PLAN REVIEW MEMORANDUM

#25-004

To: Jason Williamson - Code Enforcement Officer
CC: Chris Hanson - Asst. Code Enforcement Officer, Sandy Fredricks - Planning Board
Administrative Assistant, Jim Seymor - Town Planner, Brett Wiemken - Asst. Town Planner,
Bruce Tupper - Fire Chief, Andrew Morrell, PE - BH2M, Raymond Planning Board
From: Wayne C. Jones - Raymond Fire Inspector
RE: Brandon Chase 11-Lot Cluster Subdivision - off Cape Rd. - Preliminary Plan Review.

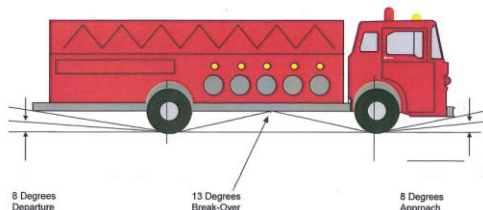
- c. The “Cul de Sac” turnaround design shall be capable of permitting a 40 ft. commercial cab, tandem axle fire truck, with a 214-inch wheelbase to turn within the designed configuration. An “Auto-Turn” or equivalent template shall be provided to the RFRD for review and approval of the design configuration.

1 c. this item was addressed in Note #17 and Attachment 2 of the BH2M “Responses and Revisions” document of 7-9-2025.
